**City of Bellevue
Development Services Department
Land Use Staff Report**

Proposal Name: Children's Hospital Phase II

File Number: 11-114943-LP, 11-124364-LO

Decisions Included: Master Development Plan & Critical Areas Land Use Permit (Process II, LUC 20.30V & 20.30P)

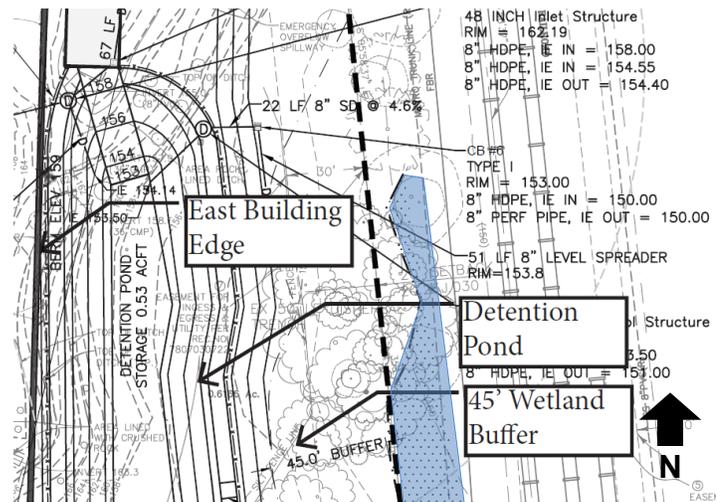
The image at right shows the far eastern portion of the project site where a Category III wetland exists as indicated in blue. It also shows the proposed limit of the future building's east edge, along with a proposed detention pond along that side of the building. The desired building line and required detention pond necessitate a requested 45 foot wetland buffer, which is a reduction from the minimum required buffer width of 60 feet (LUC 20.25H.035.A).

Proposed Buffer Reduction with Enhancement

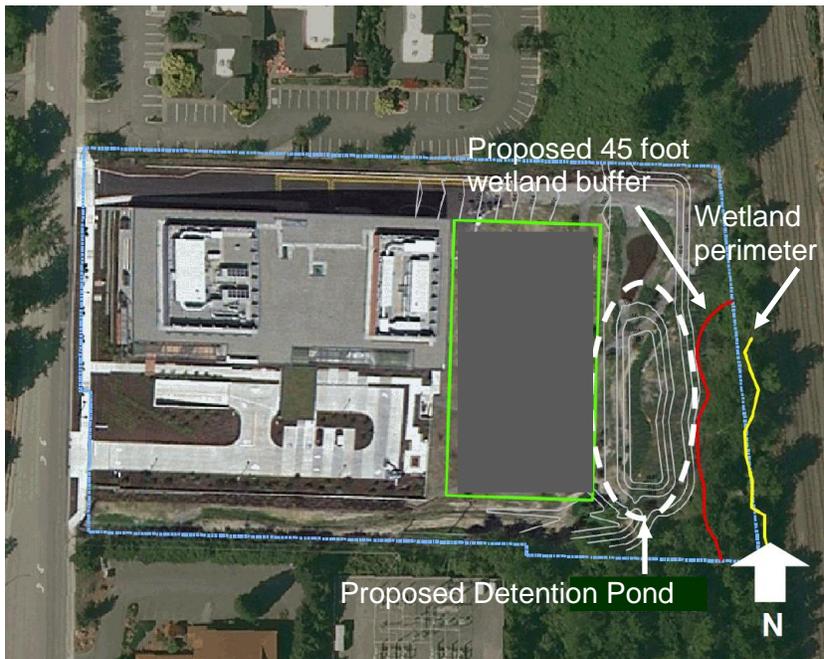
The proposed buffer reduction with enhancement would reduce the standard buffer from 60 to 45 feet, an approximately 2,500 square foot reduction. The graphic to the right depicts the wetland perimeter in yellow and the proposed 45 foot buffer in red. This proposed reduction is necessary to accommodate the proposed building and storm water management facility. Impacts to the buffer will be minimized to the maximum extent practicable. Further, much of the existing buffer area is disturbed and has a vegetation structure that provides relatively low protection of wetland habitat, water quality protection, and hydrologic support functions.

Though the buffer would be reduced by 15 feet, the proposed treatment would improve protection of the existing wetland functions. Invasive grasses and shrubs would be removed and replaced by a more diverse array of native plants. Soils would be de-compacted and amended with a lift of compost as described in Figure 4 of the CAR, and a temporary irrigation system would be installed to ensure the successful establishment of a native-plant-dominated buffer.
